KAKE SEAPLANE FLOAT RECONSTRUCTION / RELOCATION PROJECT No. 69713

SHEET 1 of 6

PROJECT LAYOUT

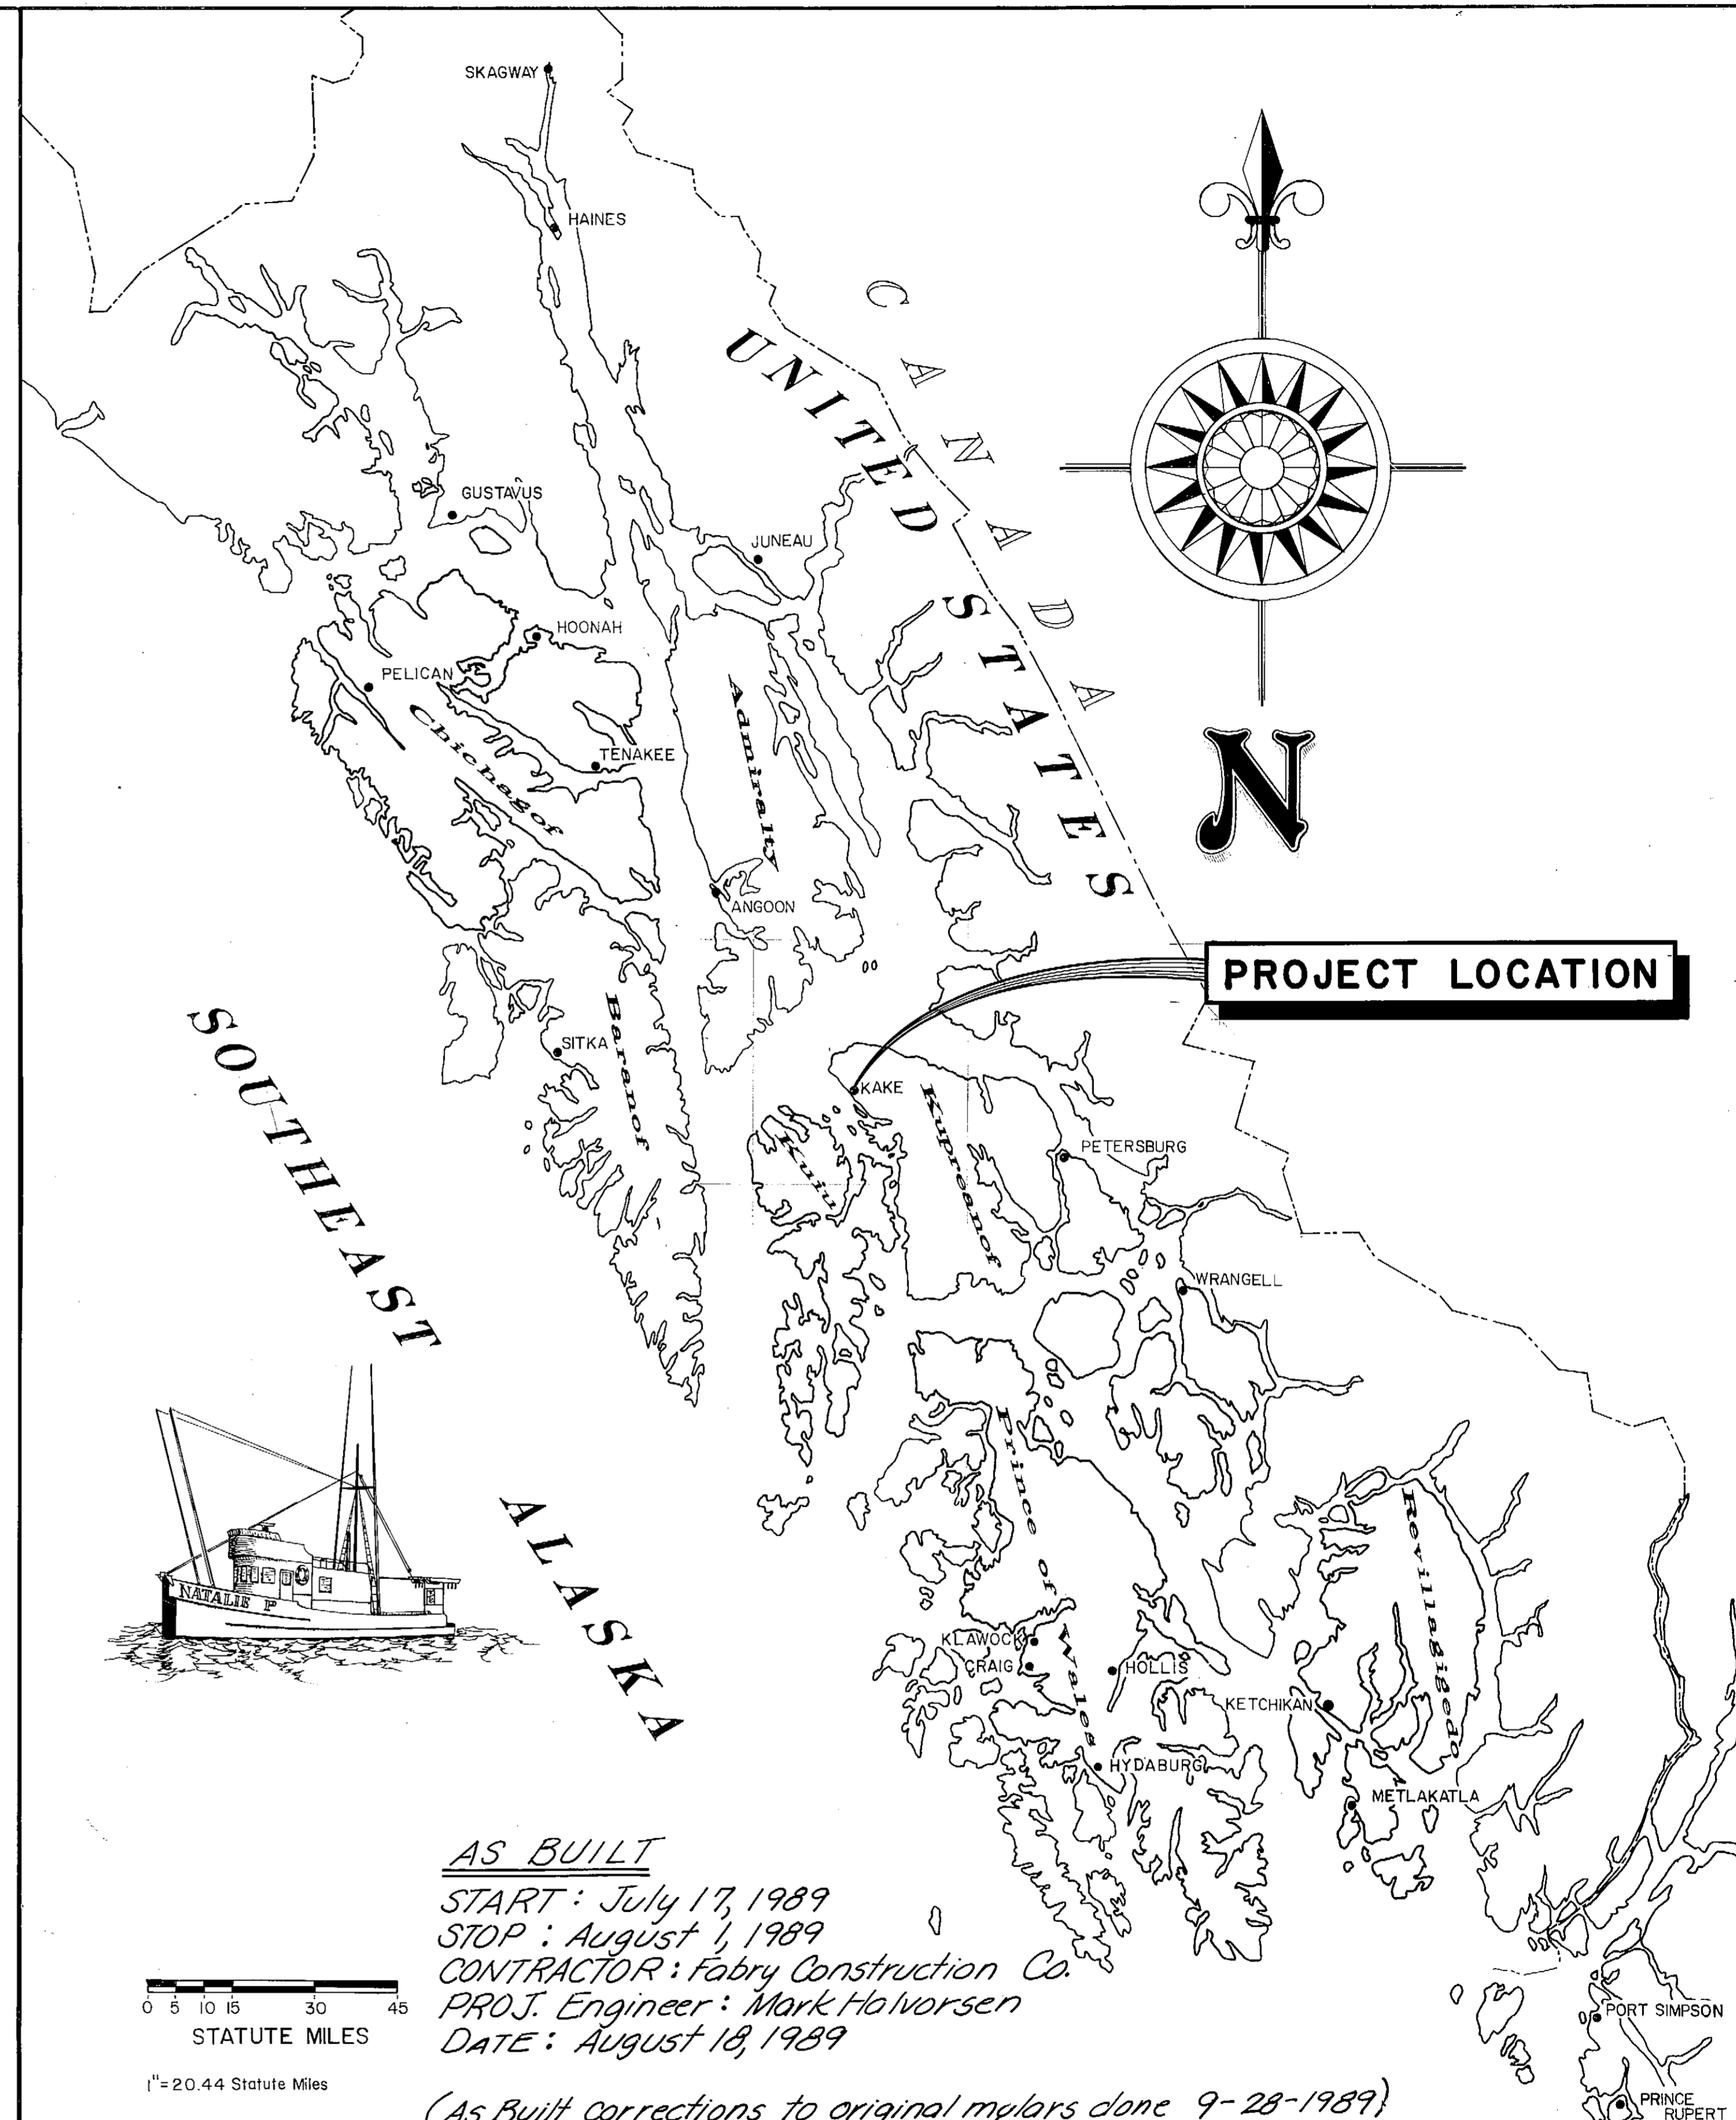
Store existing Gangway (if Supplemental A is awarded)
Gangway was taken to Ketchikan by Contractor for storage

1. PILES
 - A. Cutoff Elevation - + 27.0' * Steel piles + 22.0' (drove deeper to get additional support laterally & match existing) to get additional support laterally & more bearing)
 - B. DESIGN PENETRATION
 - a. Timber Piles - 15'
 - b. Steel Piles - 20' Timber piles 1/4" windsack + 30' (Left higher to accommodate windsack & signs)
 - c. Cutting Shoes - higher to accommodate windsack & signs) Steel piles to be furnished with APF 0-14000 open end cutting shoe or equal
 - C. PILE SIZE
 - a. Timber piles to be 26" min. tip circumference.
 - b. Steel piles to be 12 3/4" ϕ x 1/2" wall.
2. HORIZONTAL CONTROL is to be established along ϕ of the existing 87'-6" float with all intersections at 90°.
3. VERTICAL CONTROL - All pile cutoffs shall match existing pile cutoff height. See Note 1.A.

*Due to low cutoff, steel cross bar was welded inside top of Pipe Pile opening for safety.

FLOTATION ASSEMBLY DETAIL

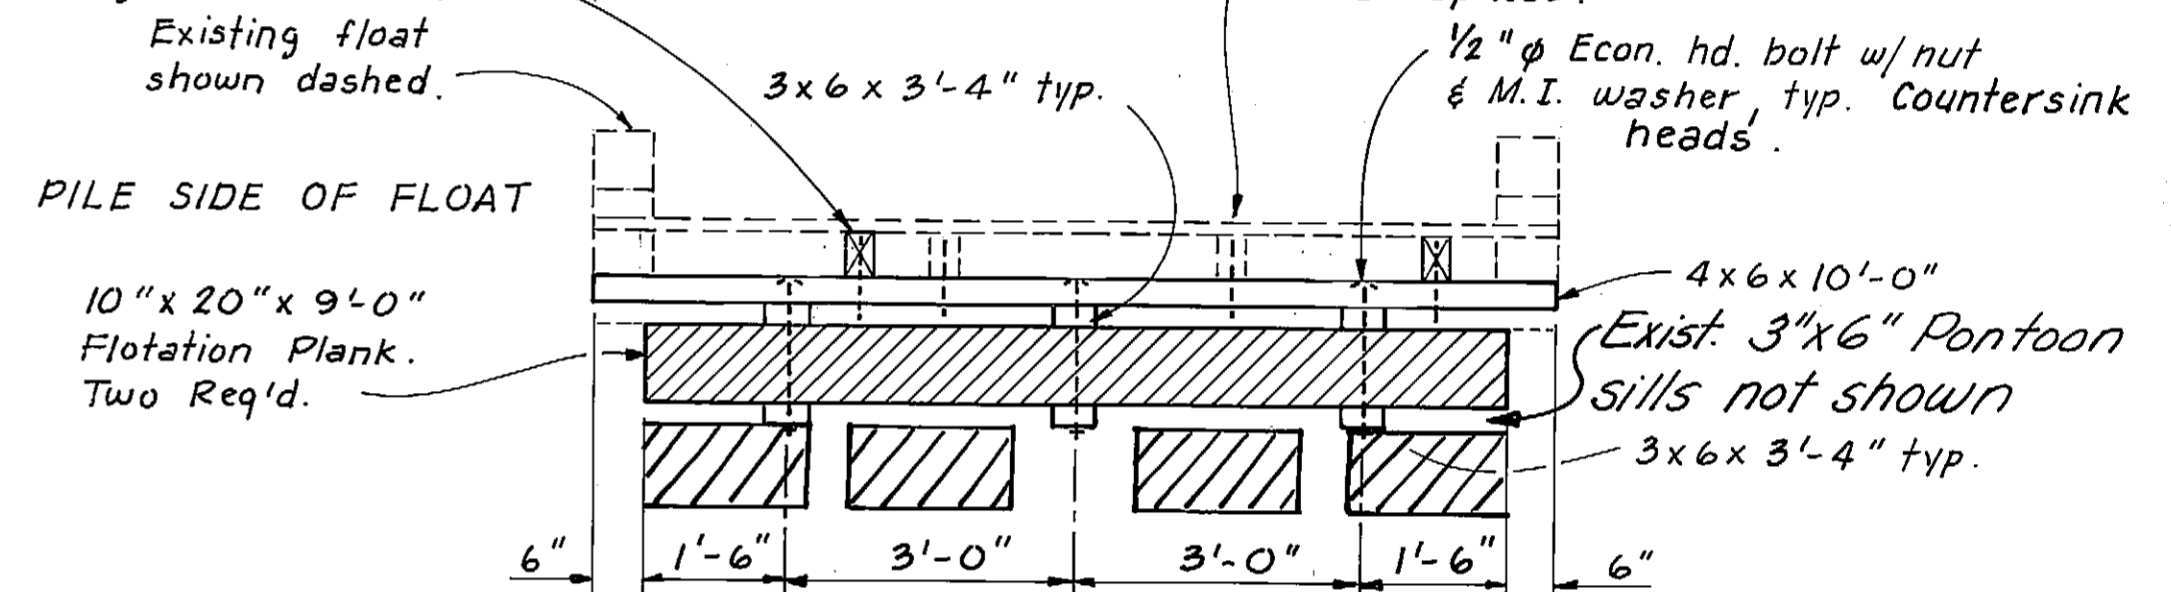
Note: New gangway connected to approach at same location as old one removed. Due to new gangway having to miss pile in inside Pile Collar in gangway float, it was necessary to angle the gangway on the float enough to miss it as the new gangway is longer than the one replaced by 15 feet. The gangway guiderails on the float are angled to fit the gangway.
